# EXHIBIT A

## STAFF REPORT COMMUNITY DEVELOPMENT DEPARTMENT

HEARING DATE: November 9, 2021

SUBJECT: H-2021-0042  
Intermountain Wood Products Expansion

D. Site Plan (date: ~~1/12/2021~~ **10/7/2021**)

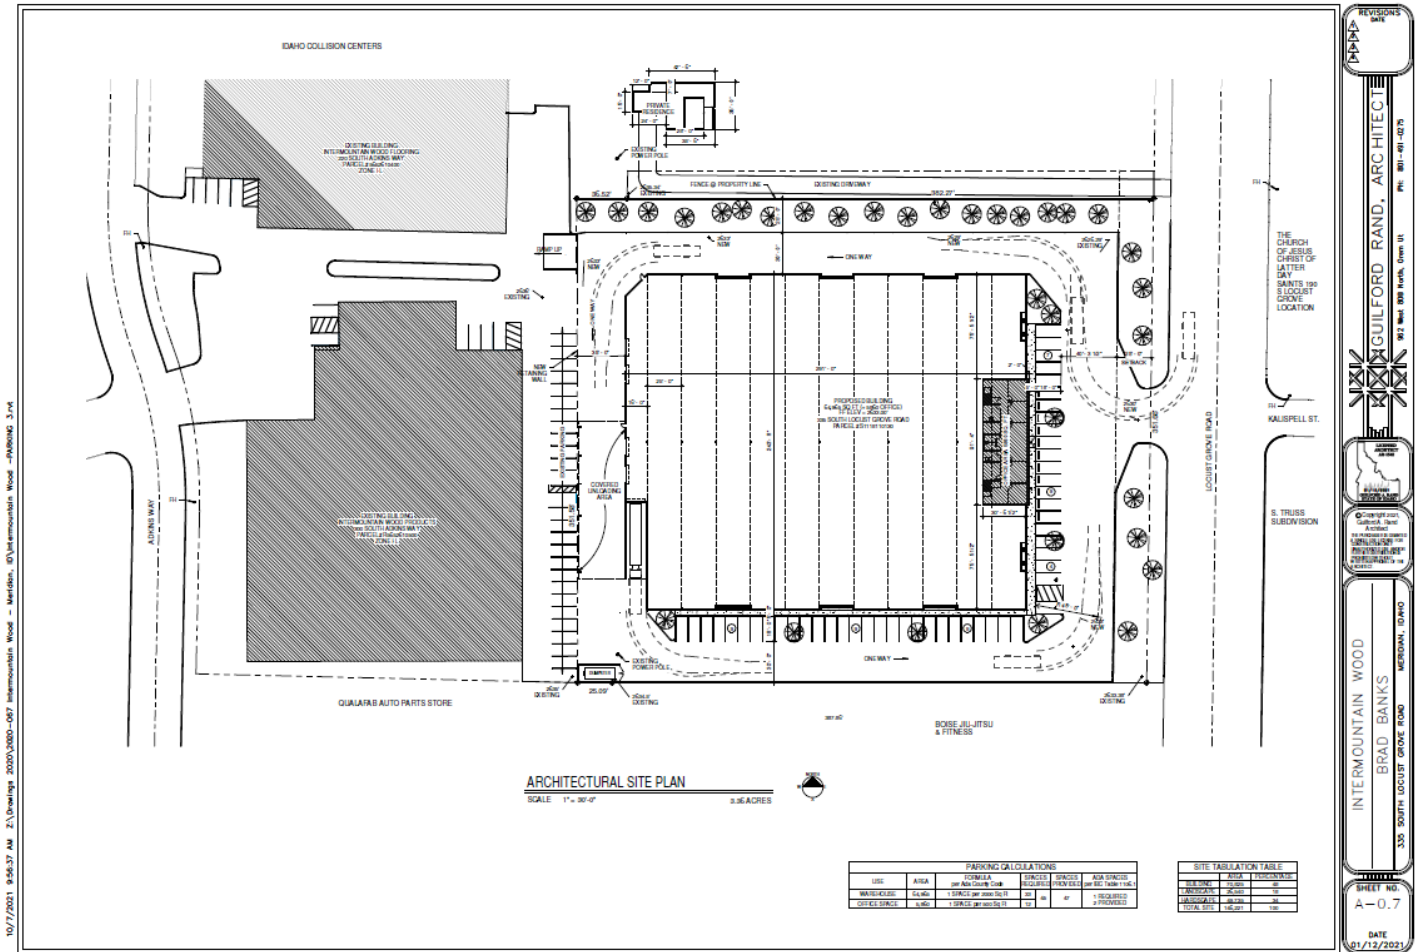
*Staff does have concerns regarding the present concept plan as will be discussed in the dimensional standards section below. Staff has red-marked on the concept plan that this plan should not be approved and future development should comply with all pertinent regulations and the Architectural Standards Manual.*

*The concept plan indicates primary access, including for trucks, occurring directly from S. Locust Grove, an arterial. Also, staff has recommended to the applicant that cross access be provided to the properties to the north and south, although the concept plan does not reflect this. Staff has addressed this in the conditions of approval.*

The site and design standards of UDC 11-3A-19 state that for properties greater than two (2) acres in size, no more than fifty (50) percent of the total off street parking area for the site shall be located between building facades and abutting streets. The concept site plan as submitted shows the entirety of the parking between the building and S. Locust Grove Rd.

UDC 11-3A-19 also requires an applicant to extend or improve streets, drive aisles, cross access easements or similar vehicular and pedestrian connections provided from adjacent properties. The concept plan as submitted does not provide access to the properties to the north and the south. As a condition of approval of the development agreement, staff is recommending cross access to these adjacent properties.

Staff does have concerns with the concept site plan as submitted because of the comments listed above. Staff has additional concerns regarding the size and visibility of the proposed warehouse

as would be viewed from S. Locust Grove Rd., and is unsure the building as shown would meet all the requirements of the Architectural Standards Manual (ASM). Although staff is overall supportive of annexation of the property for the purpose of the expansion, staff believes additional revisions need to be made to the site plan in order to be consistent with the regulations. Staff is not supportive of the concept plan as submitted.

S. Locust Grove Road is classified as an arterial roadway and is improved with 5-travel lanes, bike lanes, vertical curb, gutter, and 7-foot wide sidewalk abutting the site. The concept plan as submitted shows access for this site occurring via a 40 ft. driveway directly from S. Locust Grove Rd. The applicant has mentioned employee, customer and truck access could occur at this driveway. ACHD has noted this proposal complies with all ACHD requirements. The Council can grant a waiver to allow the access, but staff prefers the applicant develop the site plan with internal circulation and send trucks through S. Adkins Way as previously discussed at the pre-application meetings.

Staff has concerns with access occurring from S. Locust Grove Rd. UDC 11-3A-3 states where access to a local street is available, the applicant shall reconfigure the site circulation plan to take access from such local street. Also, where access to a local street is not available, the property owner shall be required to grant cross-access/ingress-egress and extend or improve streets, drive aisles, cross access easements or similar vehicular and pedestrian connections provided to adjacent properties.

During the March 2021 Pre-Application meeting, it was mentioned to the applicant that the site plan as submitted should be revised to remove primary access from S. Locust Grove, access should be provided to the properties to the north and south, and it would be preferable for truck access to occur via the existing driveway from S. Adkins Way. The concept plan as submitted does not reflect any of these access points. As a condition of approval, staff recommends the access from S. Locust Grove Rd be closed, and the site plan be revised to indicate access from the north, south and west.

UDC 11-3C-6 requires one space for every 2,000 sq. ft. of gross floor area for industrial uses (warehouse). Based on a 53,350 sq. ft. warehouse and 4,800 sq. ft. of office space this amounts to 27 parking spaces required whereas 44 are provided. However, as mentioned above in the dimensional standards section above, the parking configuration as shown on the site plan does not comply with UDC 11-3A-19 in that all parking area is located between building facades and abutting streets.

11-3C-5 requires all off street parking areas to be provided with a substantial wheel restraint to prevent cars from encroaching upon abutting private and public property or overhanging beyond the designated parking stall dimensions. When a bumper overhangs onto a sidewalk or landscape area, the parking stall dimensions may be reduced two (2) feet in length if two (2) feet is added to the width of the sidewalk or landscaped area planted in ground cover. The concept plan does not appear to meet either of these requirements.

- a. Commission noted the updated site plan that was presented at the meeting should be approved with a revision showing a northern cross access to the property at 255 S. Locust Grove Rd.
- b. Commission recommended approval with staff's recommendations and the additional recommendation that Council approve the S. Locust Grove Rd access.

- b. Council clarified the revised concept plan provided to the Planning Commission dated October 7, 2021 was the one that was being approved.

- b. **Future development of this site shall be generally consistent with the conceptual site plan dated October 7, 2021 included in Section VII and the provisions contained herein.**

- c. The S. Locust Grove Rd. access ~~shall be used for emergency access only, unless waived by City Council in accord with UDC 11-3A-3~~ **shall only be used Monday-Friday between 7AM to 5PM.**

- d. Cross-access easements shall be granted to the abutting property to the north (Parcel # S1118110071) and south (Parcels # R0879824125 and R0879824130); a copy of the recorded easement shall be submitted to the Planning Division with the Certificate of Zoning Compliance application for this site.

E. Building Elevations (date: ~~1/12/2021~~ 10/7/2021) **NOT APPROVED**

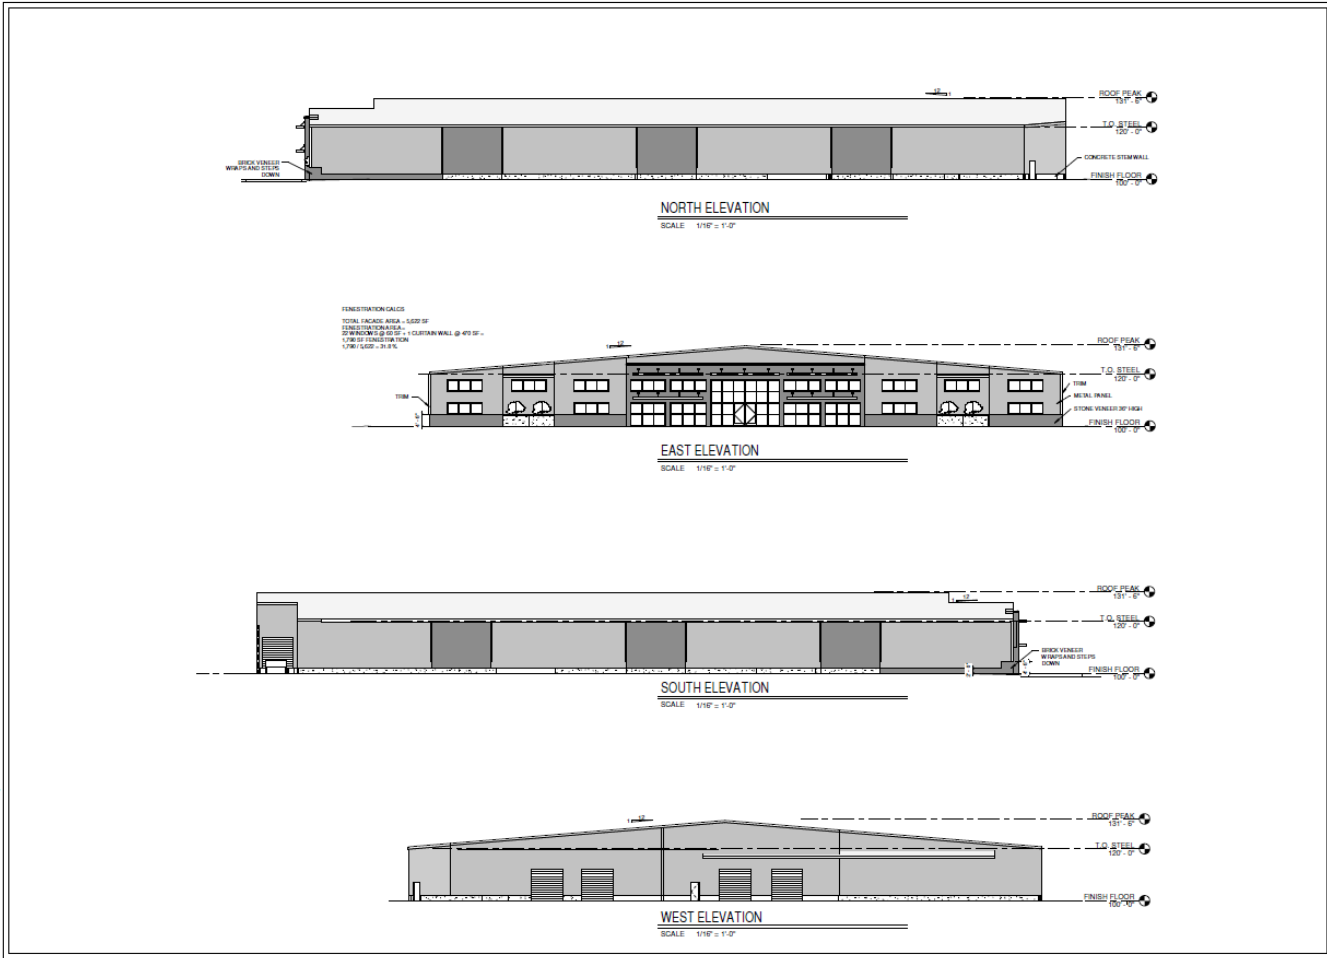
Conceptual elevations have been provided with this submittal. The elevations do not meet the minimum requirements of the ASM. This includes nearly the entirety of the building materials being metal siding, lack of accents of at least 30% along the base of the building, façade sections longer than 50 ft. without modulation, rooflines longer than 50 ft. without roofline or parapet variations, and possibly not meeting the 30% fenestration requirement or fenestration alternatives. Staff recommends the conceptual elevations not be approved. Also, due to visibility of this property from S. Locust Grove Rd and that it is surrounded on three sides by commercial and residential development, staff recommends a DA provision that requires architecture comply with the commercial, not industrial standards.

- a. Future development on the site shall comply with the non-residential design standards for commercial districts in the Architectural Standards Manual and the design standards listed in UDC 11-3A-19.
